Giant Mine Environmental Assessment

Round One: Information Request - Review Board #03

INFORMATION REQUEST RESPONSE

EA No: 0809-001

Figure 1: Simplified Model Sensitivity Analysis for Thermosyphon Performance at Chamber 12

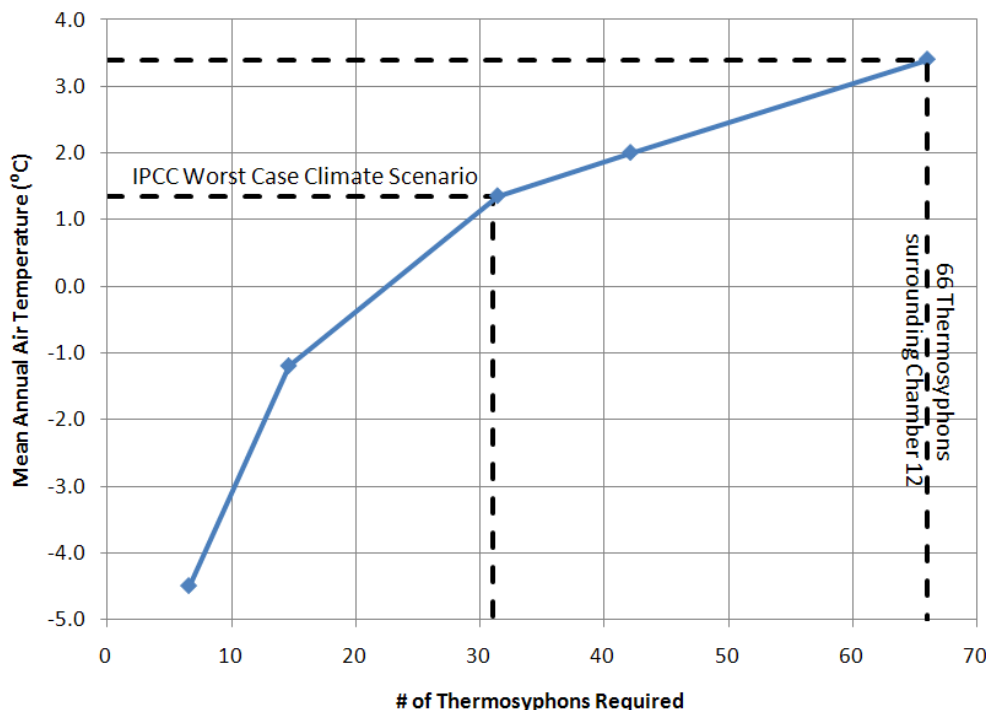
1. Please provide results of sensitivity analysis, that, independent on any assumed climate change scenario,
 - a. show the minimum air freezing index / average seasonal air temperatures required for the frozen block to remain frozen using the passive cooling method;
 - b. provide information on the energy consumption required as a function of various air temperatures for an active / hybrid system; and
 - c. provide estimates of thaw times as a function of various air temperatures, assuming that active, hybrid or passive systems fail.
2. Please present a series of graphs showing these trends.
3. Please provide electricity demands and related costs if active or hybrid freezing is required over the long term.

The simplified model presented in the DAR assumed each thermosyphon had a radiator size of 19.5 m^2 . The thermosyphons currently used in the FOS have 39 m^2 sized radiators. The figure below shows the results of the same calculations, using the revised thermosyphon radiator size and a wider range of climate change scenarios. The scenarios have mean annual air temperatures ranging from the current -4.5°C to $+3.4^\circ\text{C}$.

Calculations using a mean annual air temperature of 3.4°C resulted in 66 thermosyphons being required, matching the layout shown in the DAR. The DAR describes the simplifying assumptions used in the analysis. The limitations means the model should not be relied upon for design, but does show the robustness of the current concept.
